**Development Review Board 8/23/06 Agenda Item #26
Sketch Plat: Lot 44, Snow Heights Subdivision**

DRB CASE NO/PROJECT NO: 1005072

**DEVELOPMENT REVIEW BOARD
TRANSPORTATION DEVELOPMENT
Standard Comment Sheet**

DRB- 1005072 Item No. 26 Zone Atlas H-21

Lot 44 IN Block 125 OF Plot of Blocks 88-B to 109
INCLUSIVE, OF SNOW HEIGHTS OF ALL VM

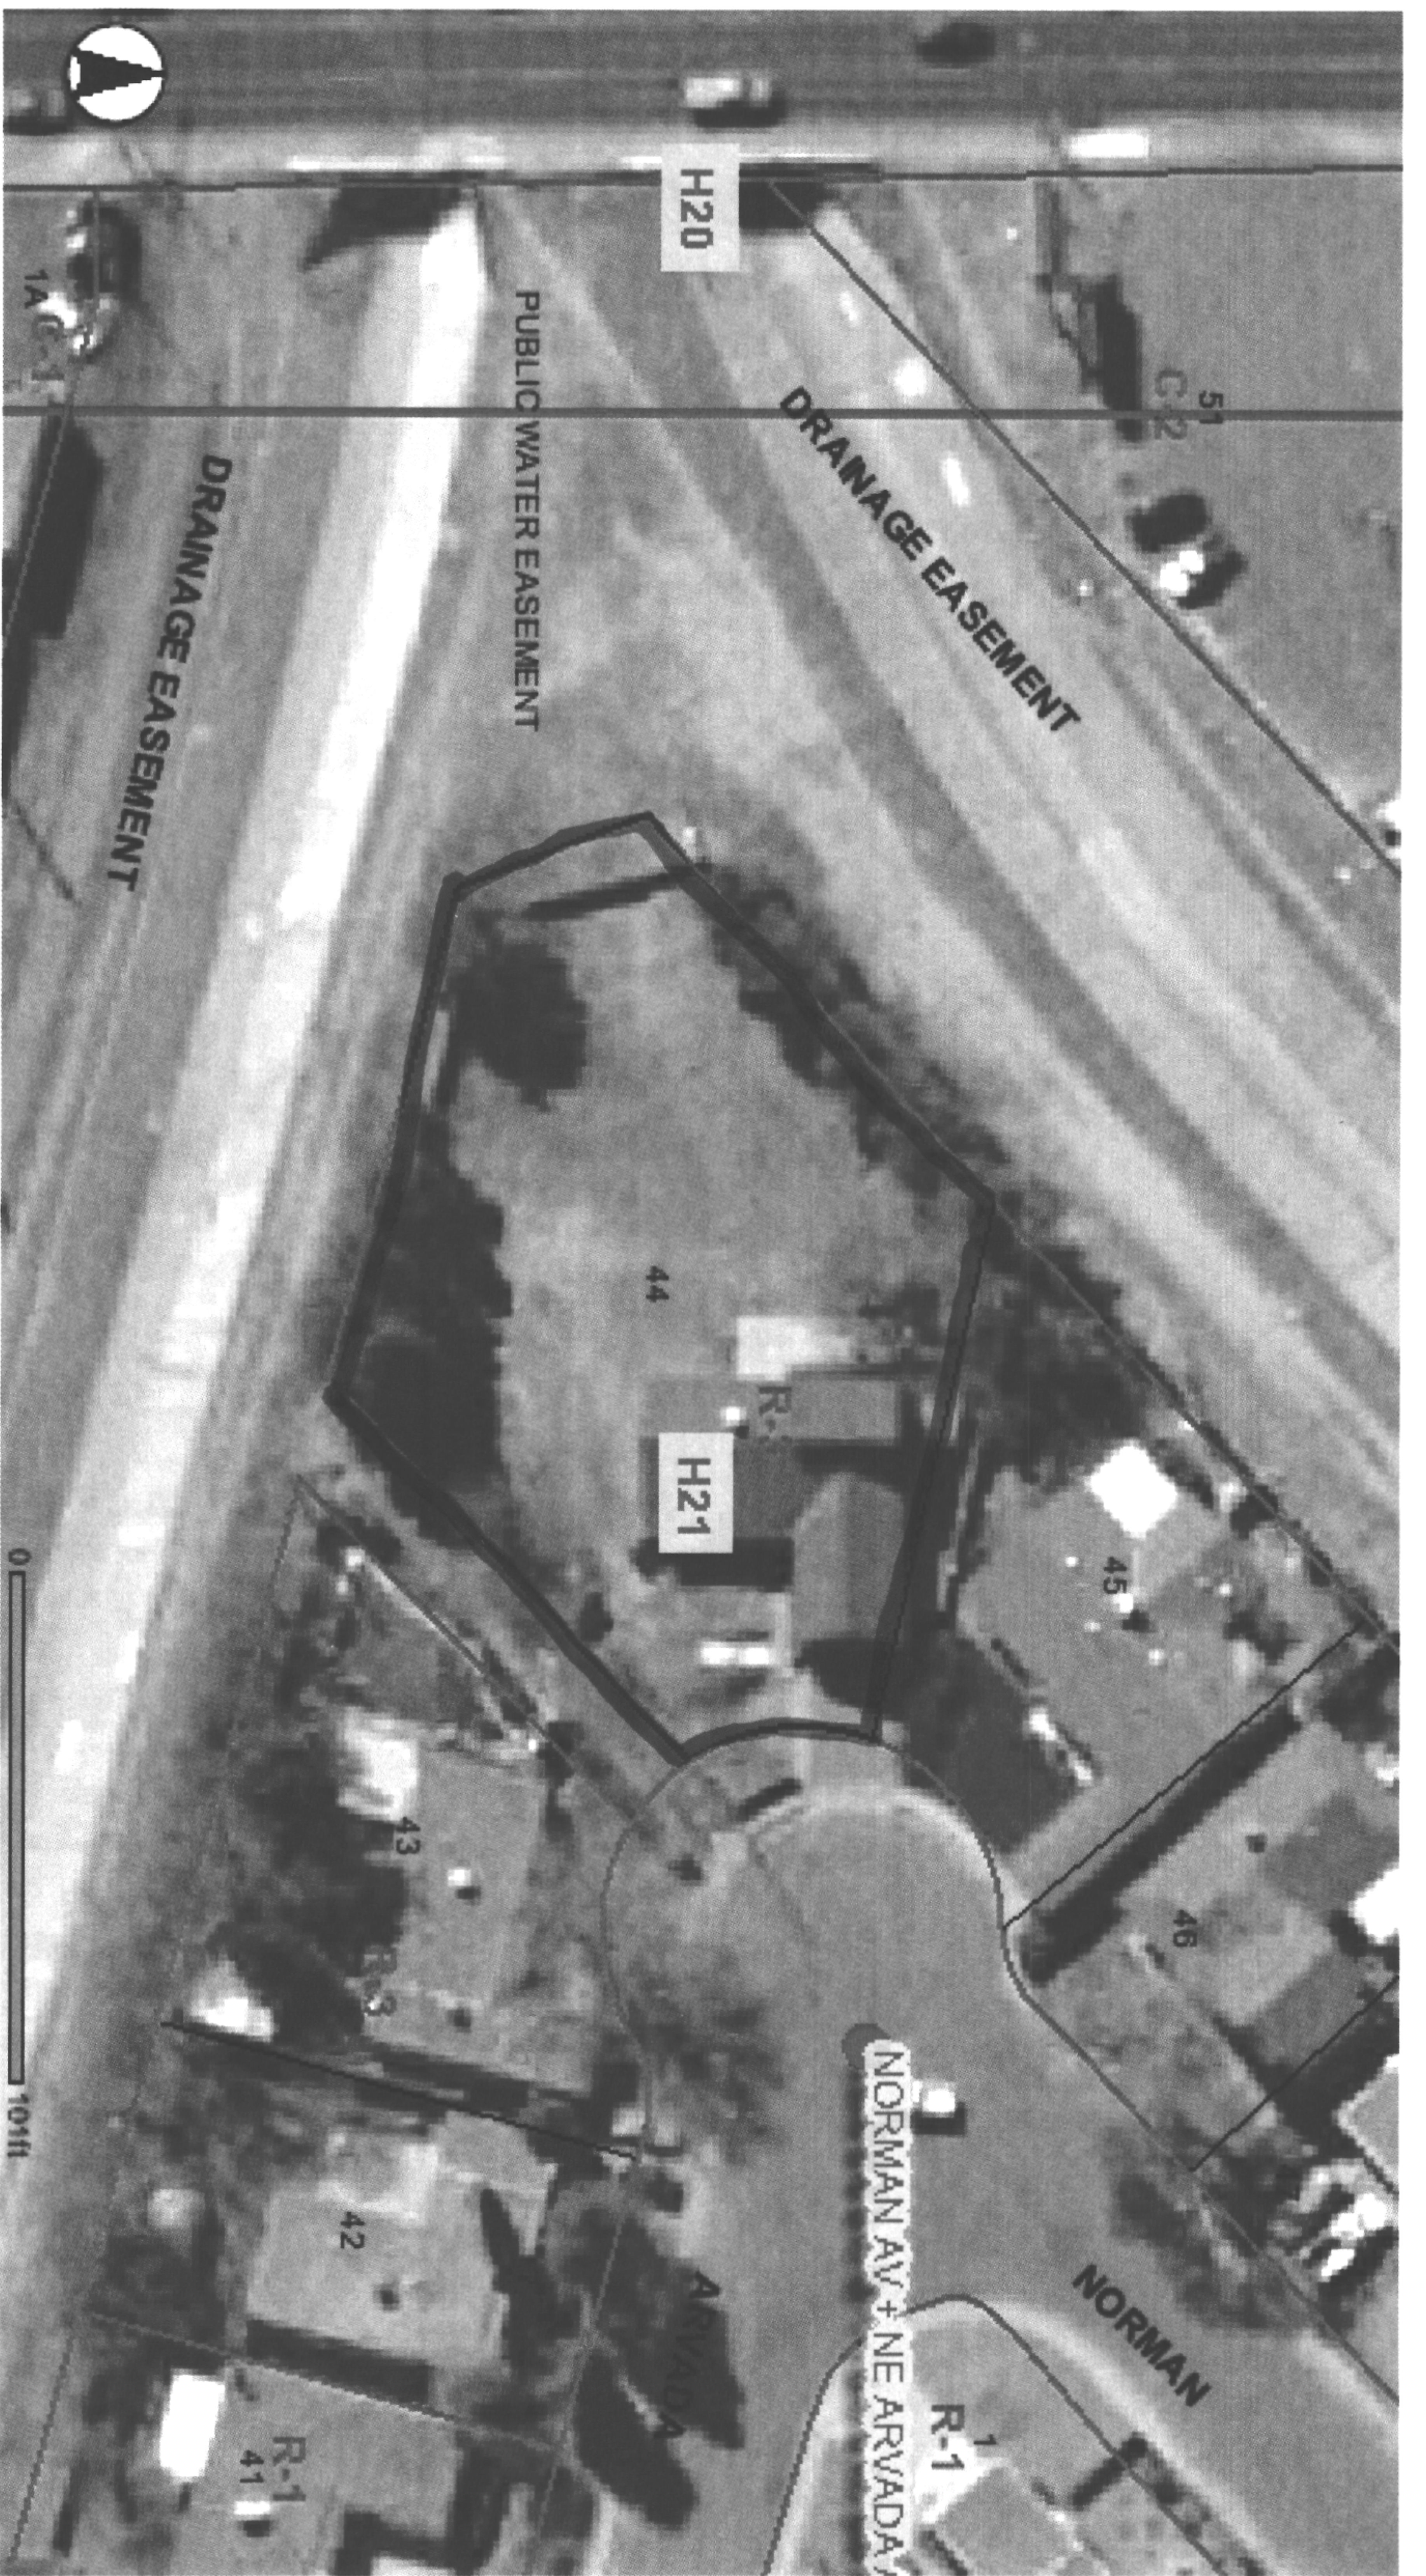
An approved drainage report is required for Preliminary Plat approval.
An approved infrastructure list is required for Preliminary Plat approval.

<u>No.</u>	<u>Comment</u>
1)	The private access easement for 5 lots is required to be 32' wide. (24' of roadway with a 4' sidewalk)
2)	What is the length of the easement? (Unsure if a turnaround is required)
